Project Location Brighton Neighborhood, City of Boston

Provisos from 5/26 Hearing

Exterior Door Alterations Bigelow Street Door

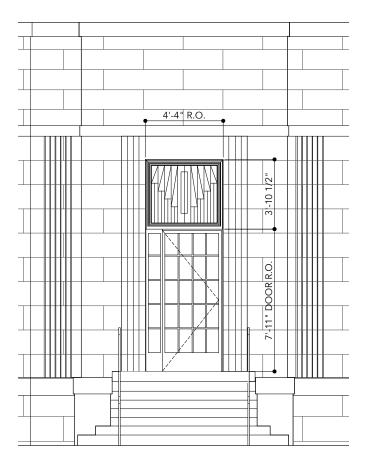
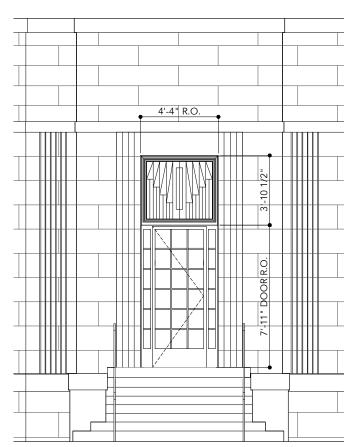
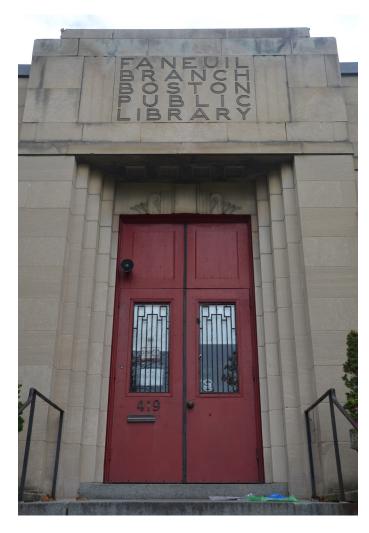
- Commissioners would like more information about the proposed alterations to the main entrance on Faneuil Street and the side entrance on Bigelow Street.
- Consider centering the door at the Bigelow Street entrance.
- Consider a more solid reading at the Faneuil Street entrance.

- Offset glass door with single sidelite
- Door width: 3'-4 1/2"
- Sidelite width: matches door divided lite width

- Centered glass door with double sidelite
- Door width: 3'-0'
- Sidelite width: 0'-6"
